ADDENDUM No. 2

HICKORY GROVE LAKE
LOW WATER DRAIN PIPE AND VALVE
STORY COUNTY, IOWA
PROJECT NUMBER: 16-02-85-03

May 21, 2018

DAM AND SPILLWAY PLAN

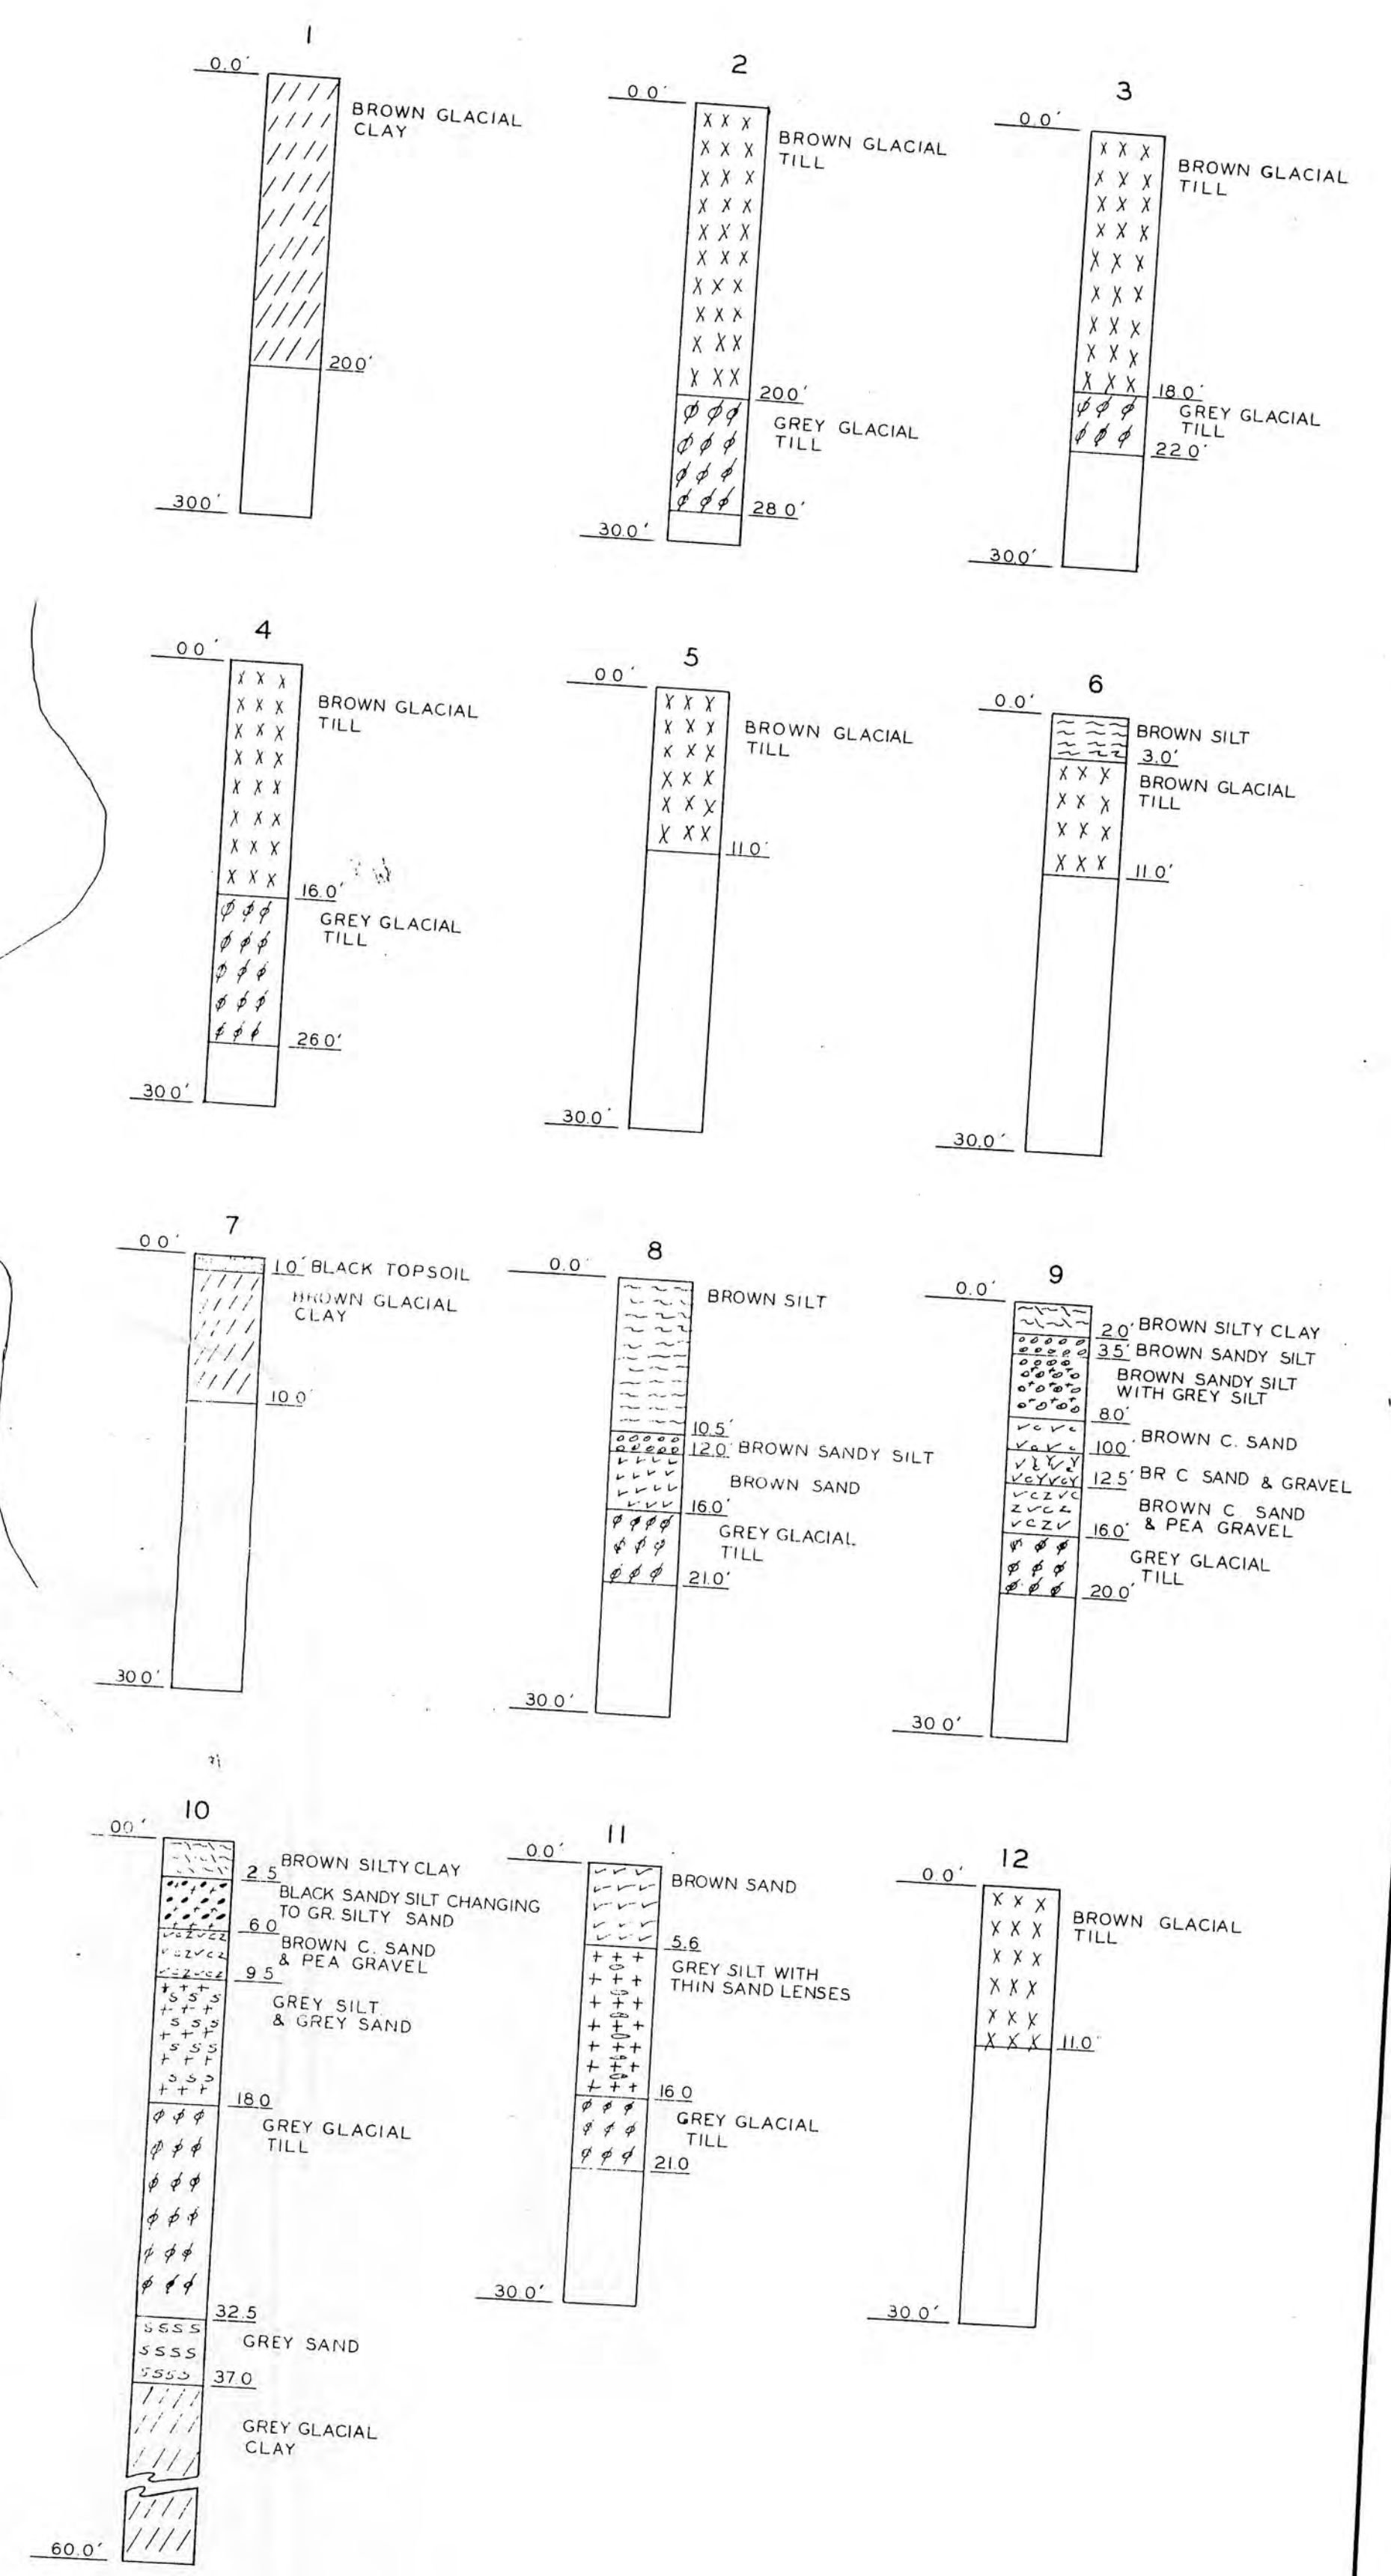
A revised plan sheet will not be issued, however a schematic from the original plan set and bathymetric map of the pool area is provided as Attachment 1 and Attachment 2 respectively. The original plan set for the dam indicates that the original channel may have been near elevation 933.0, and the proposed launch pipe is near elevation 937.0 based on the bathymetry.
